Modification of Development Consent

Development consent: **SSD 7628** granted by the Planning Assessment Commission on 31 January 2018

Modification: The modification includes:

- adjustment to the southern boundary of the site to facilitate a revised drainage system layout and design for Onsite Stormwater Detention Basin (OSD) 2
- removal of the requirement for maximum batters of 1V:4H for OSD 9.

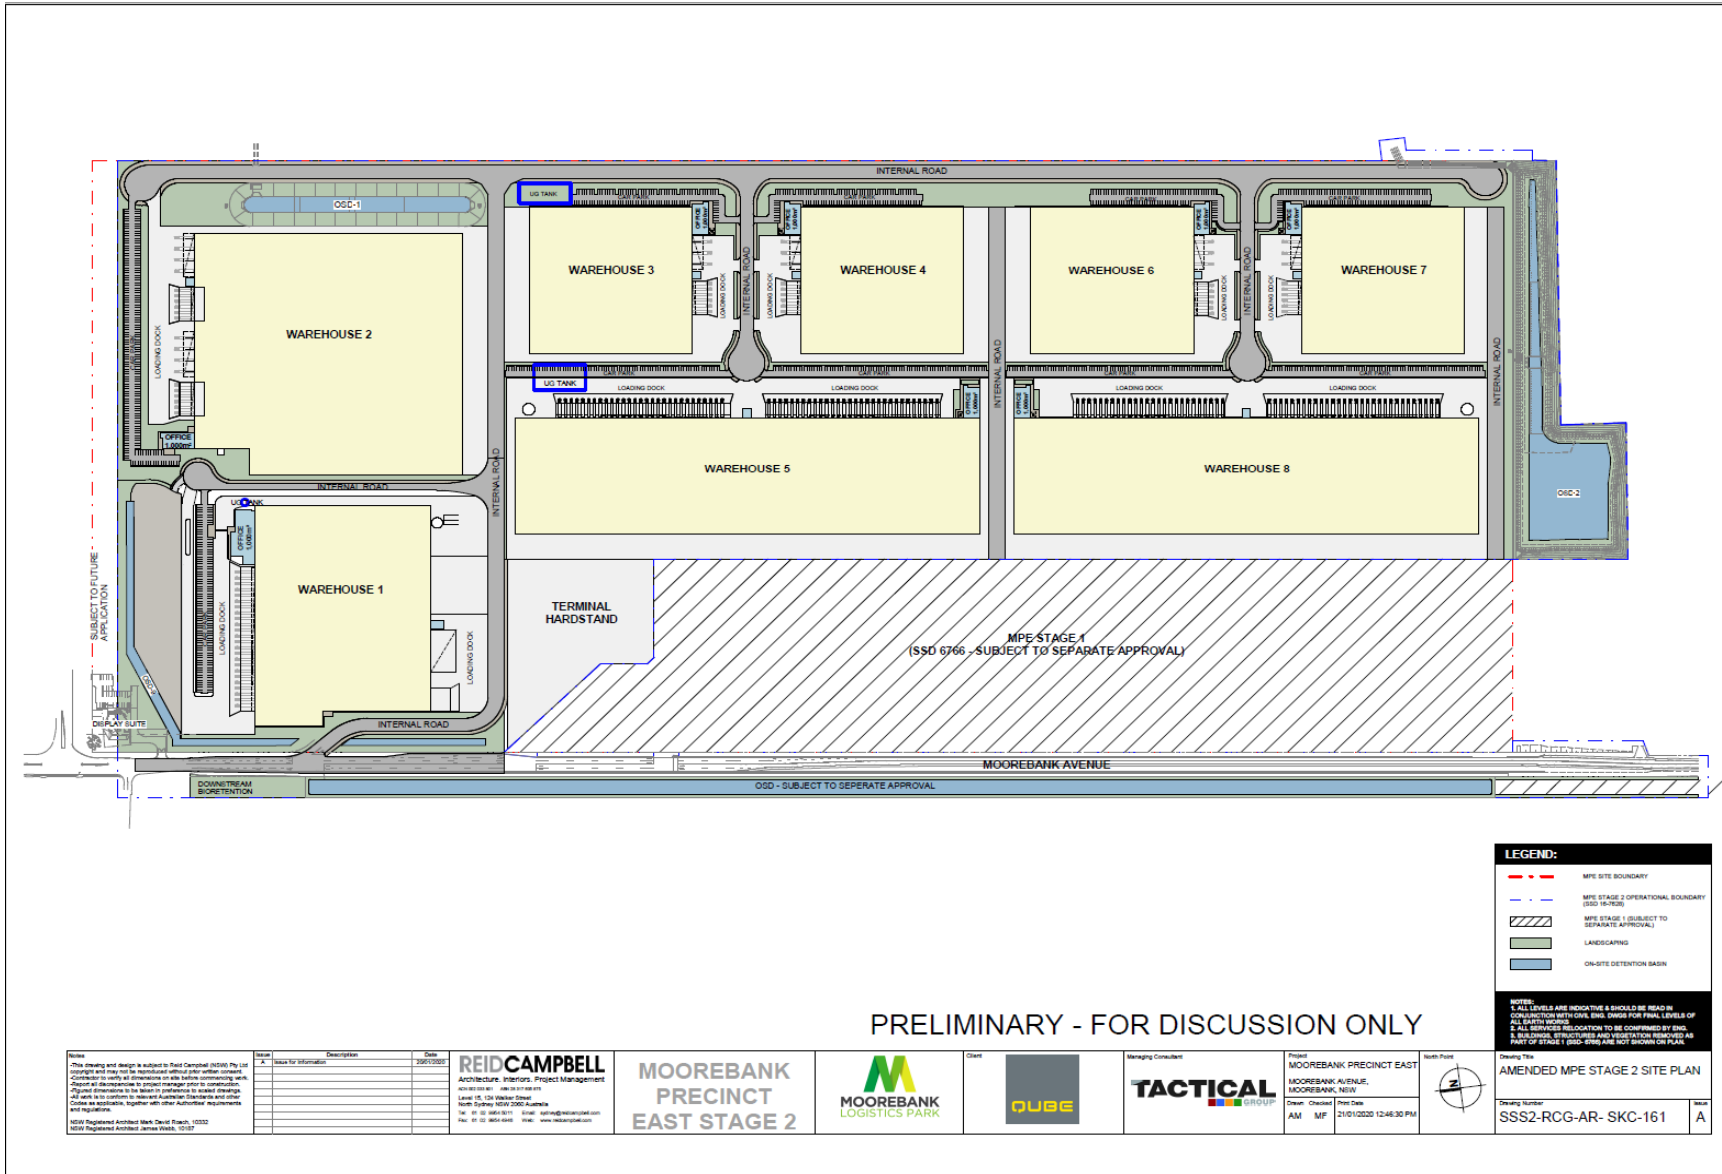
Appendix A is amended by deletion of the existing figure 3 and insertion of the following figure:
